1 **802.3da Power Management Draft Baseline Text**
2 **12 September 2023 - Campinas, Brazil**

Figure 147-2—10BASE-T1S PHY interfaces

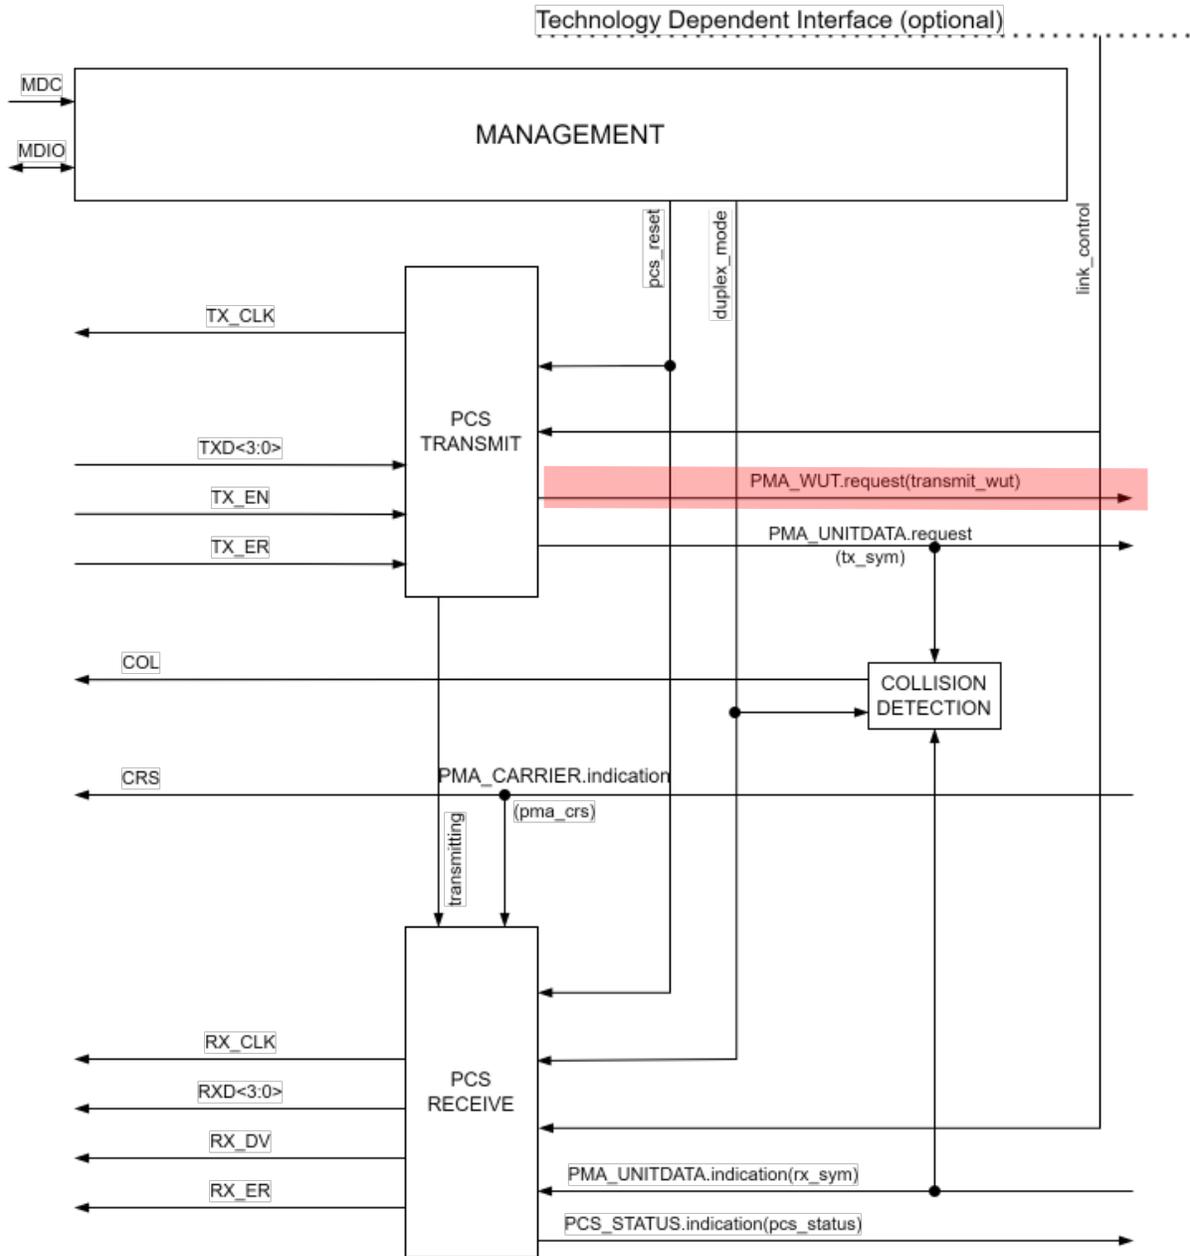
4 *Update Figure 147-2—10BASE-T1S PHY interfaces with this one.*

Figure 147-3--PCS reference diagram

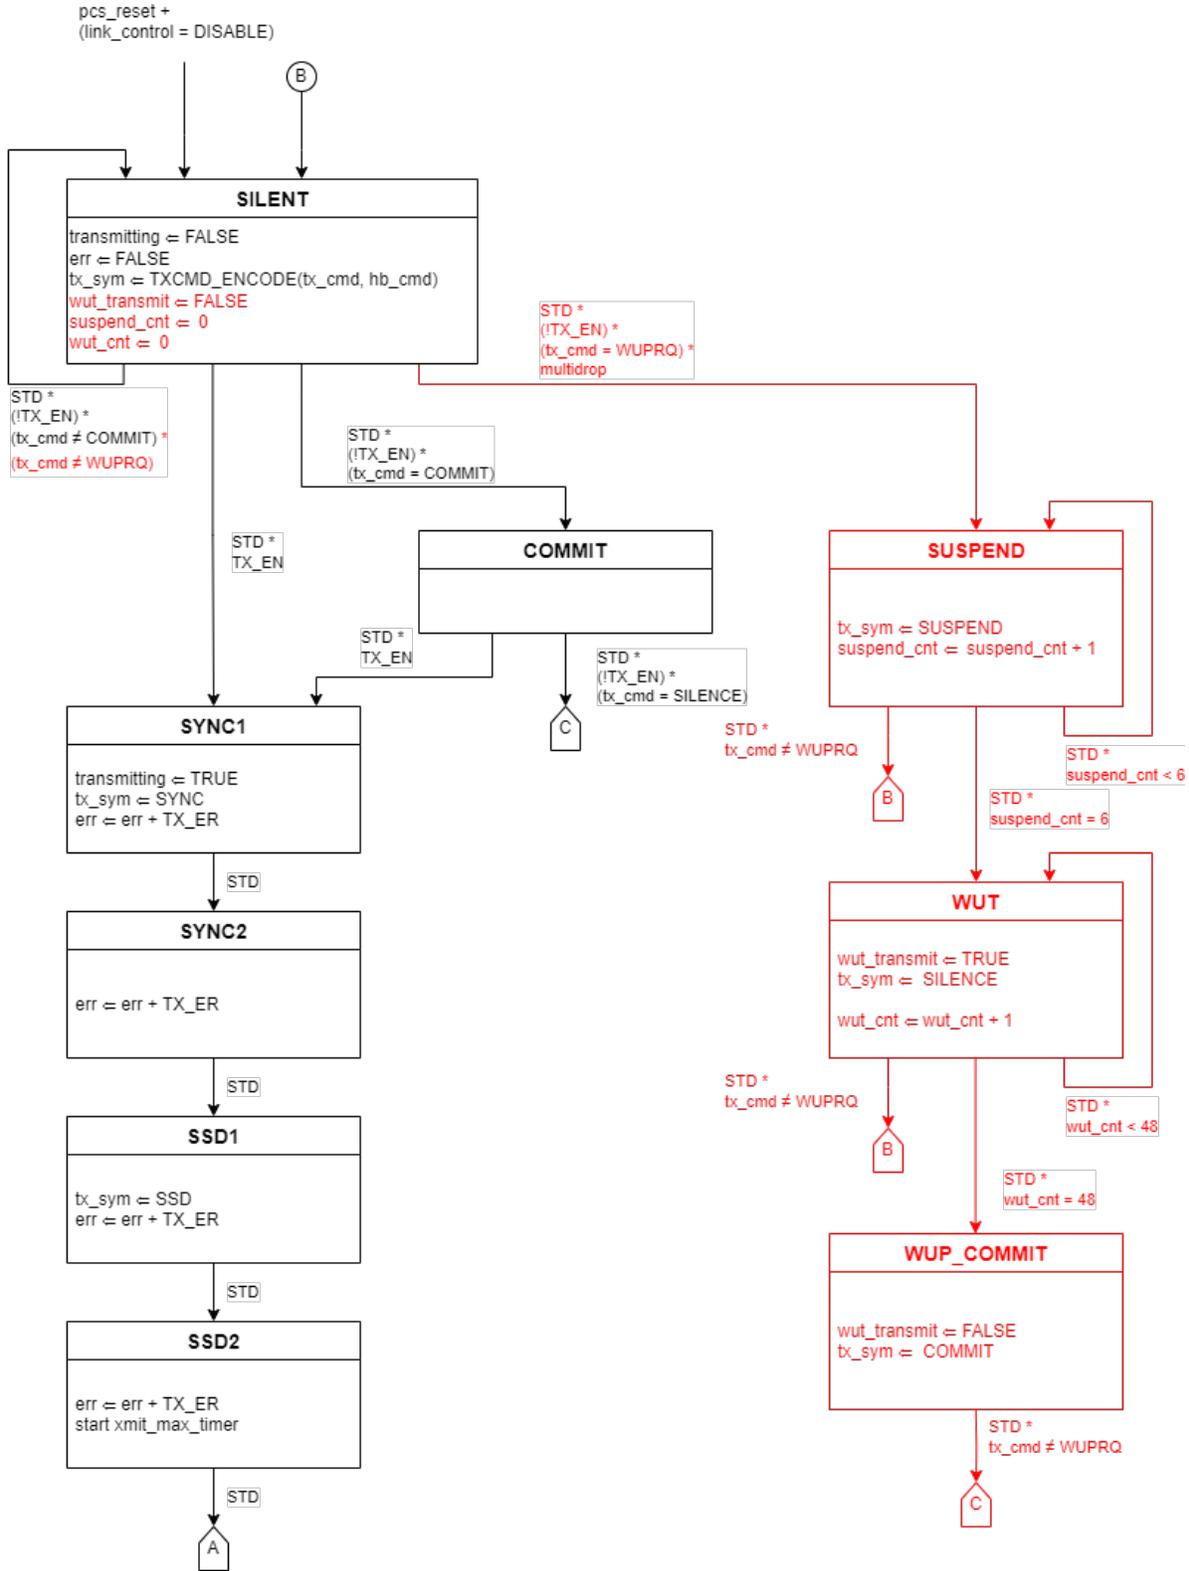
25 *Replace figure 147-3 with the following.*

Figure 147-4--PCS Transmit state diagram, part a

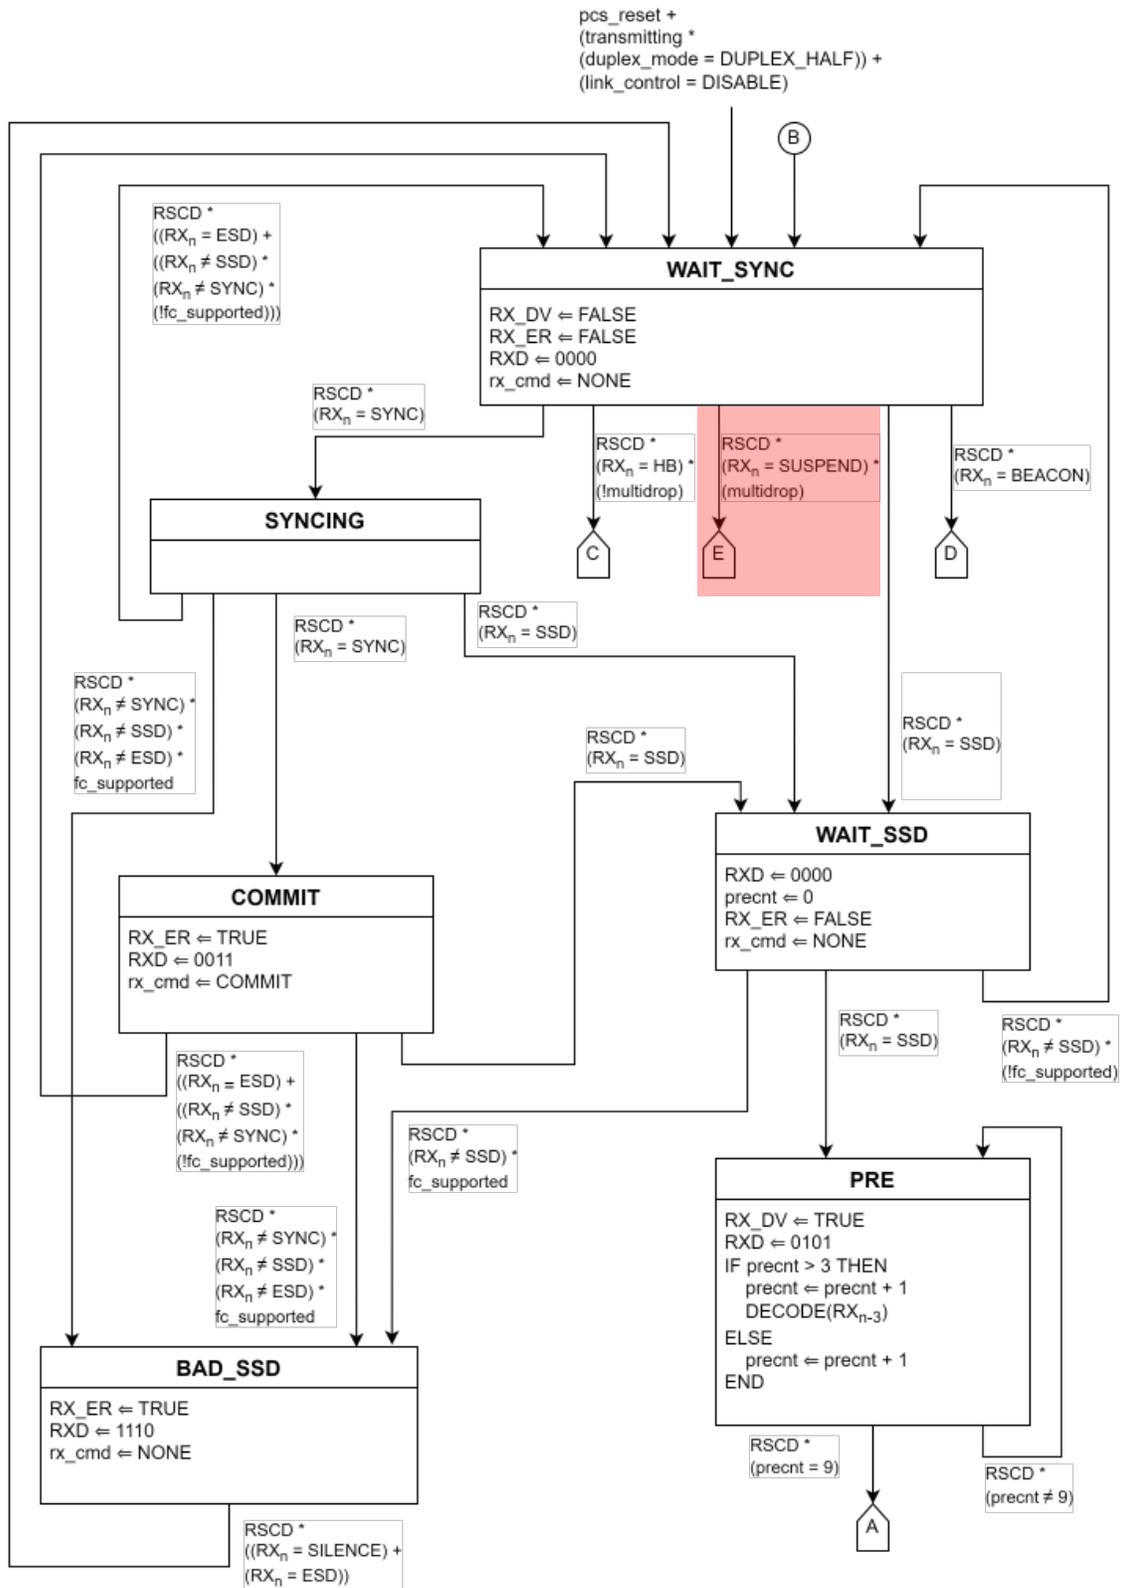
2 *Replace figure 147-4—PCS Transmit state diagram, part a*

Figure 147-7--PCS Receive state diagram, part a

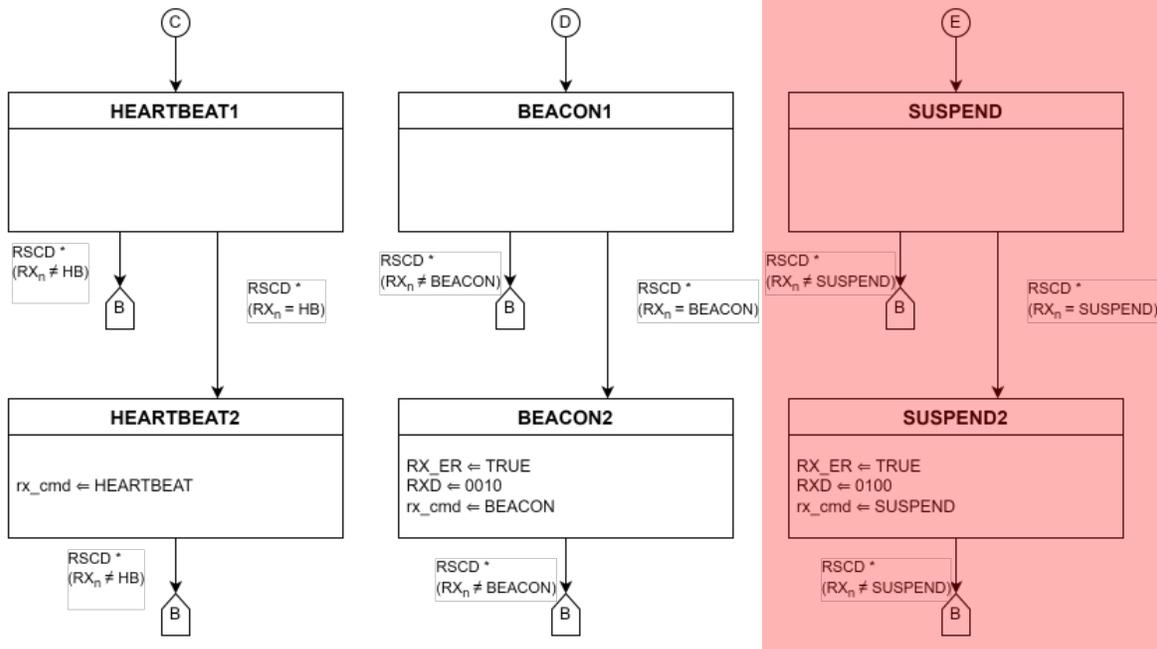
13 *Add the additional exit path from the WAIT_SYNC state of PCS Receive state diagram, part a (Figure 147-7) as shown.*

Figure 147-8--PCS Receive state diagram, part b

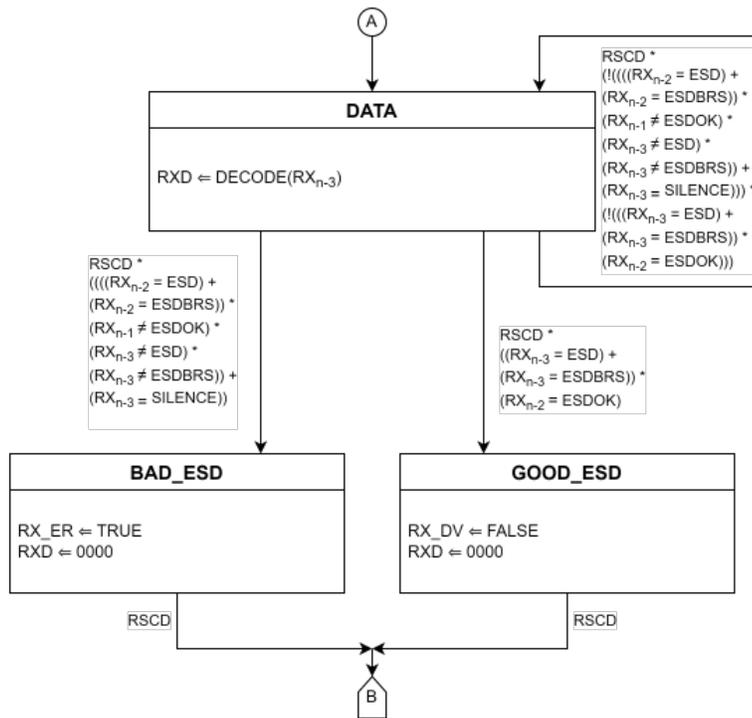
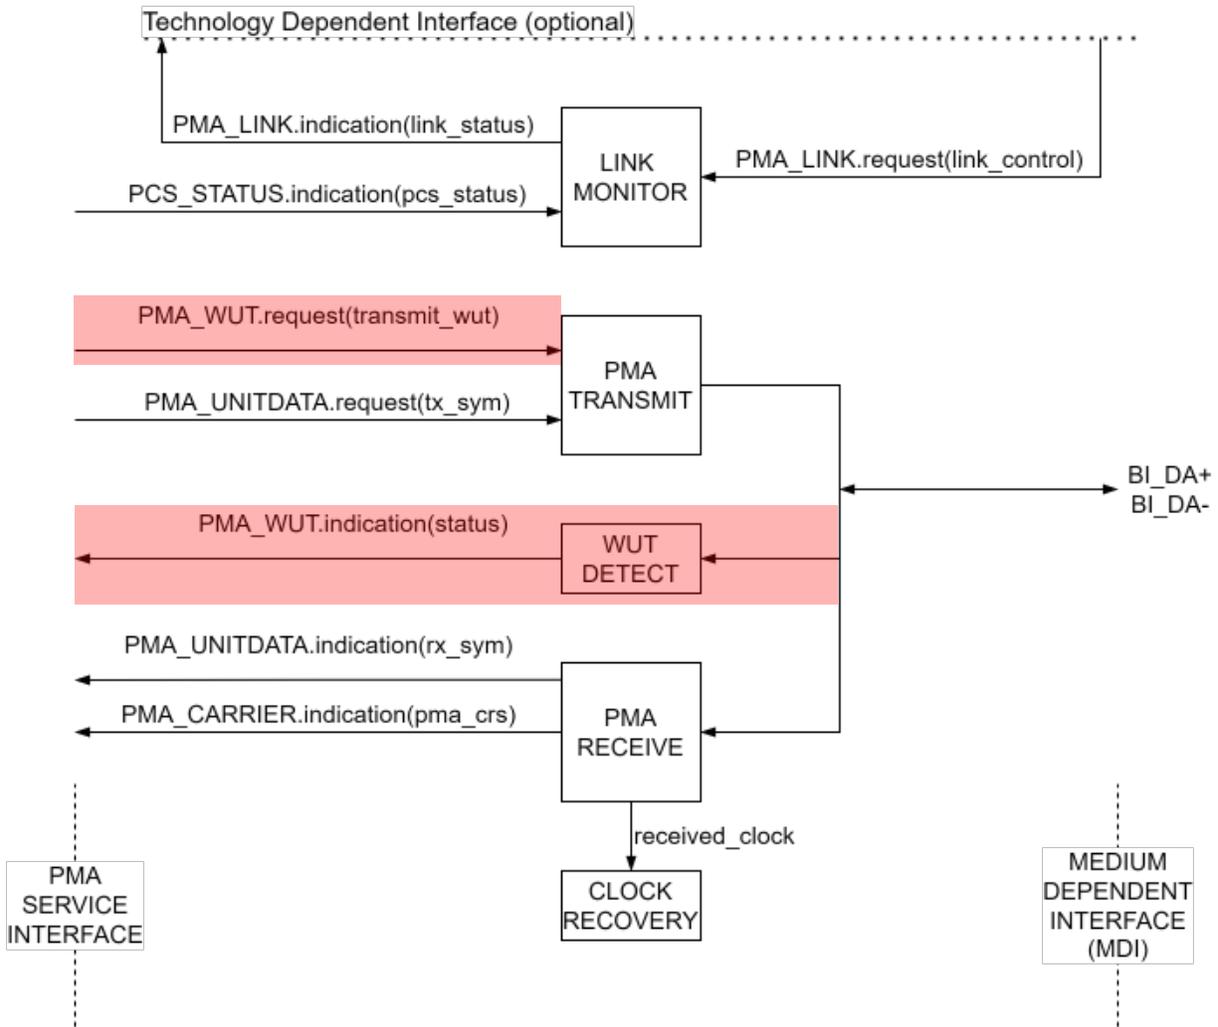
1 Add the additional SUSPEND and SUSPEND2 states to PCS Receive state diagram, part b (Figure 147-8) as shown.

Figure 148-3--PLCA Control state diagram, part a

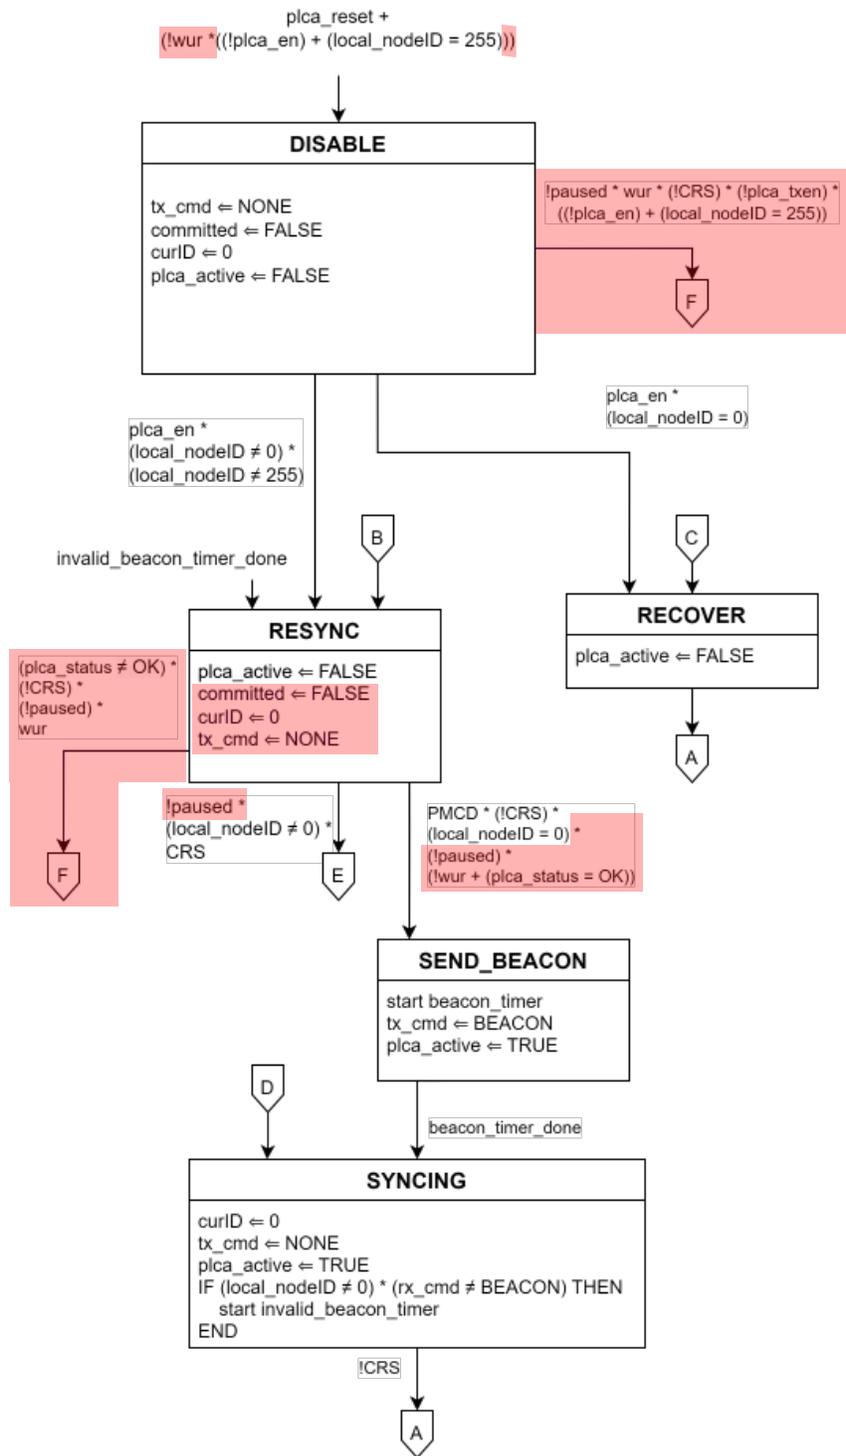
- 1
- 2 **148.4.4.6 State Diagram**
- 3 *Update Figure 148-3 and 148-4 with the following.*

Figure 148-5—PLCA Data state diagram, part a

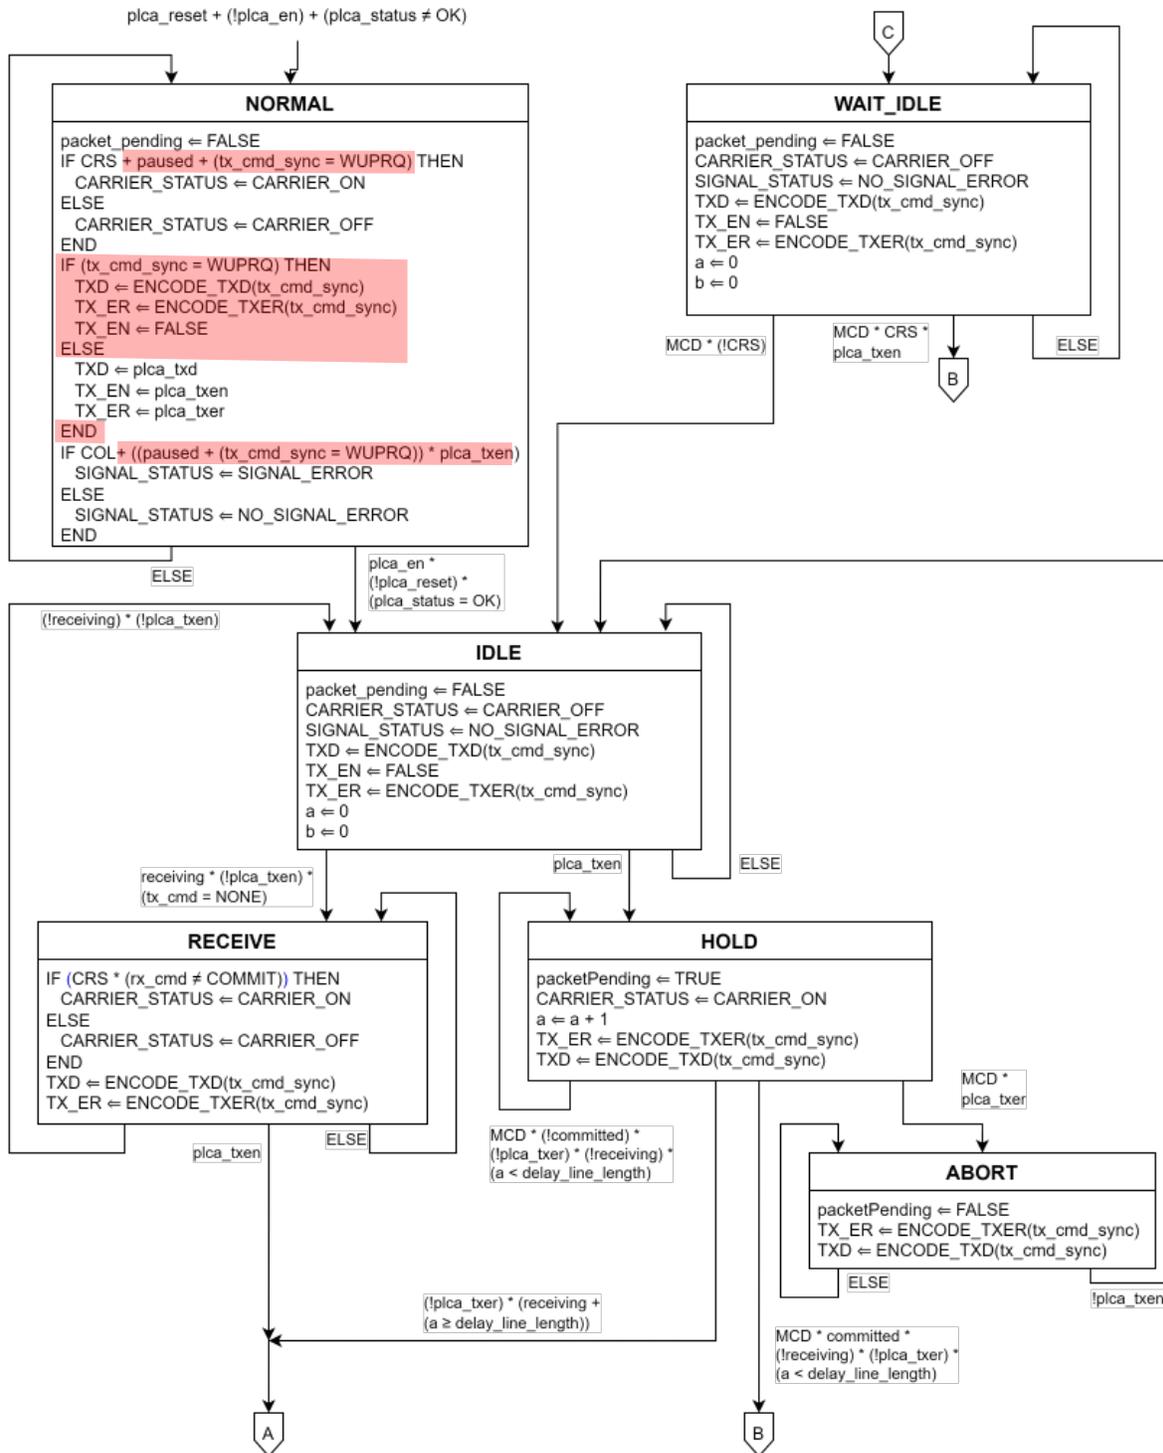
5 Update Figure 148-5—PLCA Data state diagram, part a with this one.
